4th Further Information

**Temporary Warehouse (Excluding Dangerous Goods Godown) and
Associated Filling of Land for a Period of 3 Years in "Agriculture" Zone,
Lot 973 RP (Part) in D.D. 107, Fung Kat Heung, Kam Tin, Yuen Long, New Territories**

(S.16 Planning Application No. A/YL-KTN/1163)

Response to Comment

3

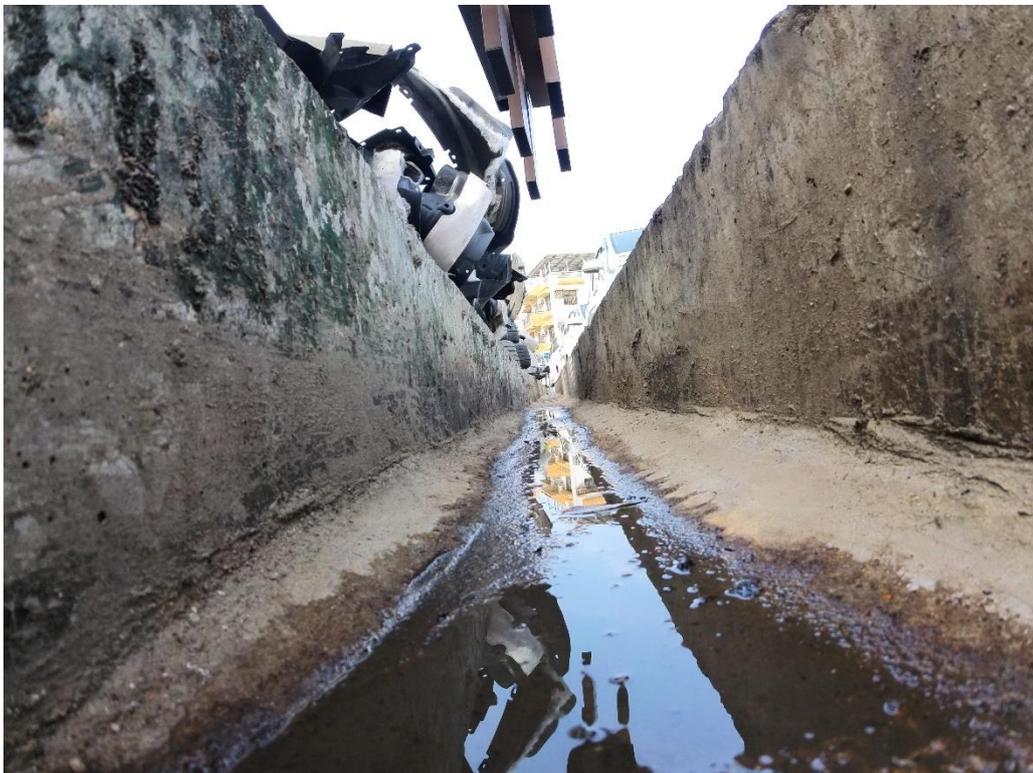
(a) Photos 3, 15 and 16: Wire mesh was found in existing catchpit that water flow might be obstructed.	The wire mesh is removed. Please refer to the updated photographic record showing the existing drainage facilities on the application site (Annex I).
